Delegated Report

Variation of Conditions

Planning Application No: 20260232

Description: Application for variation of condition 2 (Plans) and condition 7 (Carport plans) attached to planning permission reference number 20231227 for Erection of a two storey side extension and a two storey rear extension with catslide roof incorporating 2no. rear dormers and detached 3 bay car port.; to allow infill between oak posts in car port and addition of windows and enlargement of kitchen window.

Proposed plan and elevations	Approved plan and elevations
------------------------------	------------------------------

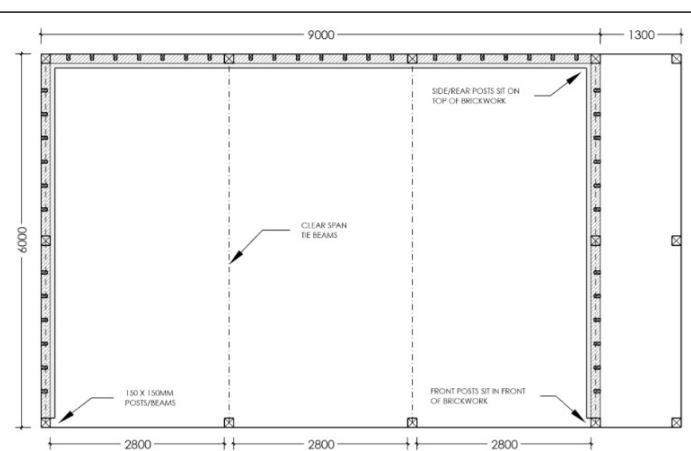
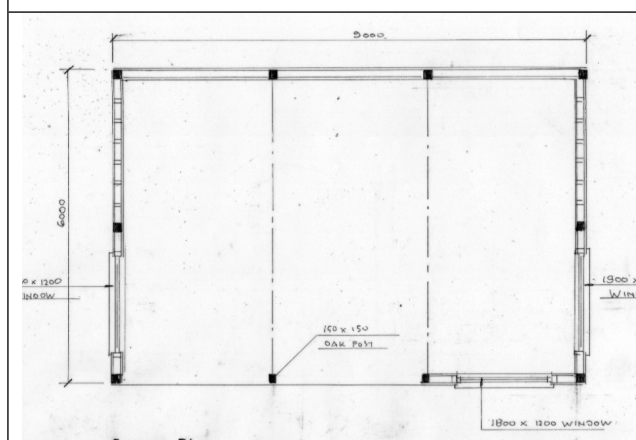
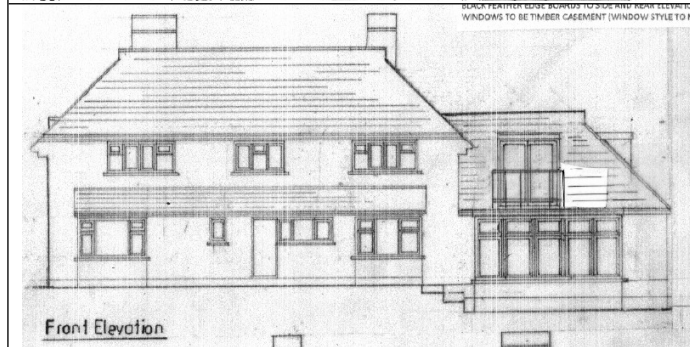
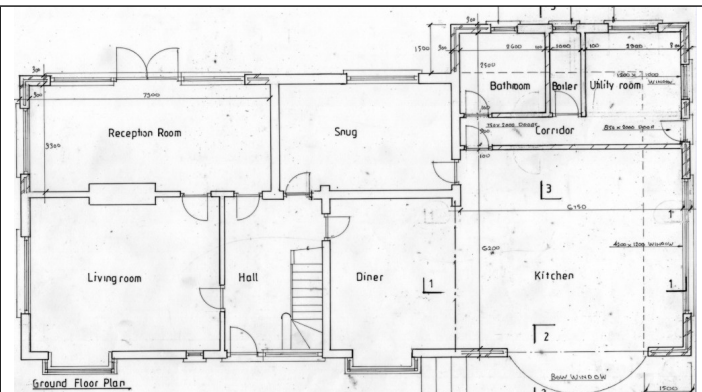
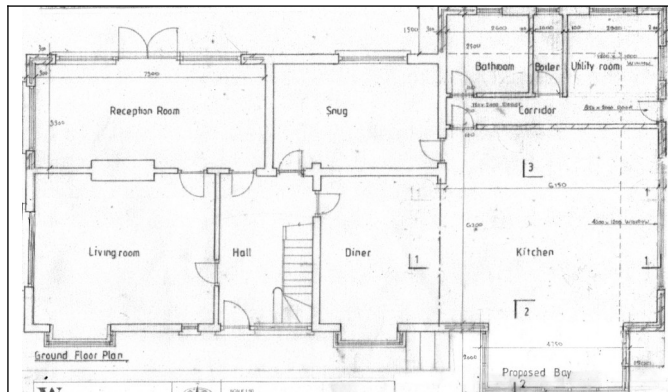
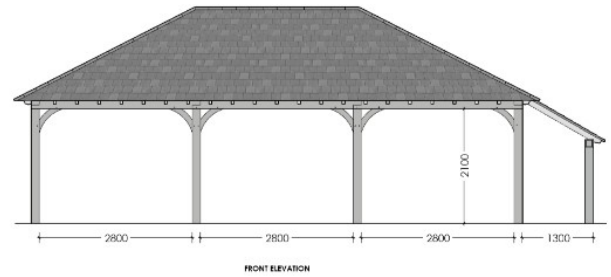
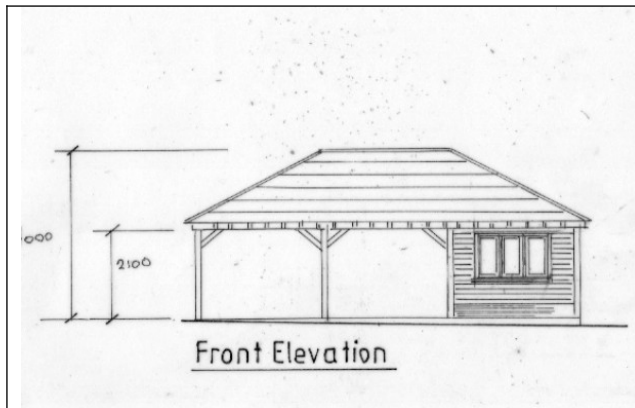
1. Carport - windows in the sides and infilling of one bay, also with a window:

The carport does not appear to be exactly the same design as in the original plans, which had an open lean-to area at one side.

Putting side windows in a carport is unusual, as is infilling the front of one bay also with a window. The purpose of the alterations and the proposed future use of the infilled area is not stated and this should be clarified, however Condition 8 (and all others) of permission 20231227 is not being altered. The Parish Council therefore has no objection in principle to this proposal.

Enclosing 1 bay of the three bay carport and adding two windows, one in the existing side wall and the other in the new side wall will leave two bays at the front of the structure still open. Any attempt to completely enclose the structure or change its use would generate a strong objection from the Society, but the Society has no objection to what is proposed.

The proposal seeks to add a flat roofed bay window to the front elevation of the building, in the place of the originally approved curved bay window. The flat roofed bay window would have a width of approximately 4.75m and would project 2m forward of the property's front elevation. The bay window would be an oak framed bay window with casement windows which would match those to the existing dwelling. The oak frame would give the bay window a traditional appearance and would match the existing timber detailing to the front elevation, which would help to ensure the bay window harmonises well with the dwelling.

The proposal also seeks to enclose part of the frontage of the car port, and add windows to the side elevations. The changes to the carport would not result in an increase in its footprint or scale. The changes would somewhat domesticate its appearance through the introduction of windows, however, as two thirds of its frontage would remain open, the changes are considered not to result in a harmful change in

It is considered that the proposed changes to the originally approved car port and front bay window would comply with Policy CS19 of the Gravesham Local Plan Core Strategy (2014).
